Meeting Date:
July 8, 2024

Request: Preliminary
Subdivision review of
Canterbury Crossing

Hudson Planning Commission	PRELIMINARY SUBDIVISION REVIEW
Case No. 2023-676	CANTERBURY CROSSING

Figure 3

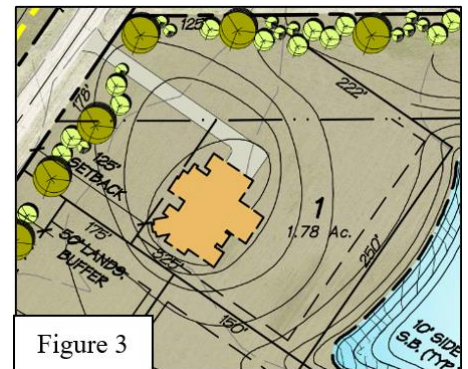
Staff Comment: All buildings are depicted with a minimum setback of 100 ft from the perimeter property line; however, staff notes sublots #1 and sublot #13 would have significant portions of the lots with the minimum 100 ft structure setback. In conflict with the conditional use standards referenced under section 1206.

Figure 4

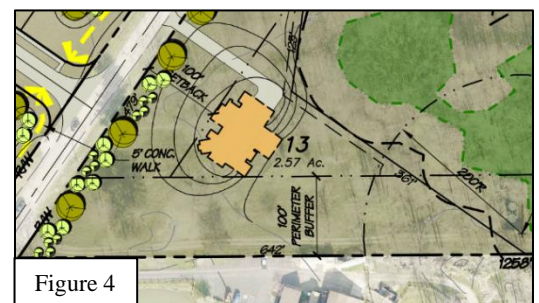
Staff Comment: A substantial bufferyard is depicted within the 100 ft perimeter setback; however, landscaping would need to be verified for sublot #13 (See Figure #4). Staff notes the proposed limits of disturbance indicate existing vegetation would be preserved along the southern property line; however, the extent is not captured on the landscaping plans. Removing this sublot out of the 100-foot perimeter will allow the protection of existing vegetation to count towards the required bufferyard.

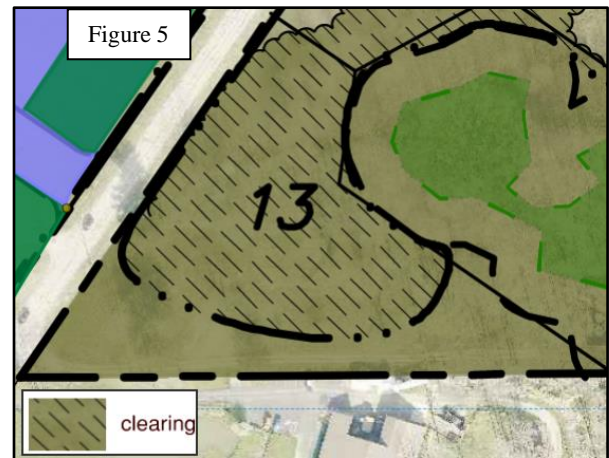
Staff suggests the removal of subplot #13 per the following findings:

1. The proposed lot shape does not fit with the proposed development or surrounding existing lots. Section 1208.05 states *the lot size, width, depth, shape, and orientation shall be appropriate for the location of the subdivision and type of development and use contemplated.*
2. In order to accommodate a new house on this lot substantial clearing would be required (see Figure 5). Staff notes the proposed lot is located adjacent to an existing single family house lot.
3. As previously mentioned, this is one of the few locations where the required perimeter property setback would not incorporate dedicated open space as discussed to comply with applicable conditional use standards.

1. Remove subplot #13 to comply with the lot design standards, tree clearing standards, and minimum density standards and to establish a 100 foot depth open space acreage at the subdivision boundary.

Figure 7

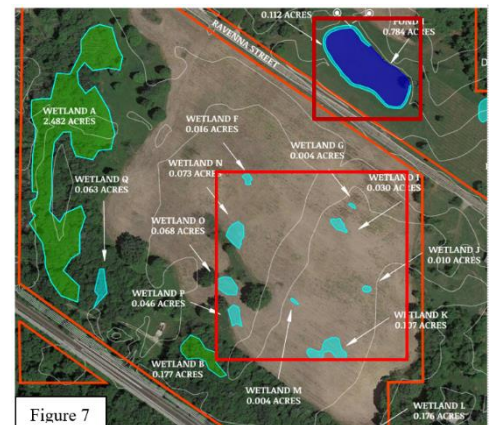
The applicant states the 0.496 acres of wetland highlighted would be proposed to be filled to accommodate the new home construction on the south side of Ravenna Street and at the proposed street right of way. The applicant states these wetlands are expected to be classified as isolated and only under the direct jurisdiction of the Ohio EPA. Disturbance of these wetlands would additionally require a variance request to the BZBA.

Figure 8

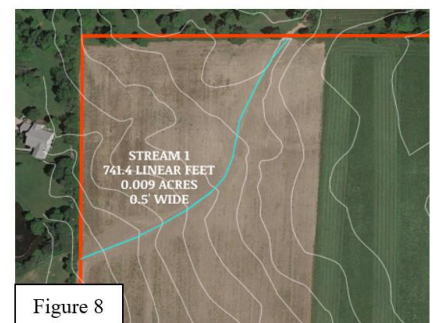
The applicant is proposing the identified stream to be re-routed and integrated into a stormwater basin. Staff notes remnants of clay tile piping has been observed within the stream bed, suggesting the stream was once a controlled drainageway. This area, if regulated as a stream, requires riparian setback protection which must be depicted on the plan. Any modification to the applicable standards would require a variance request to the BZBA.
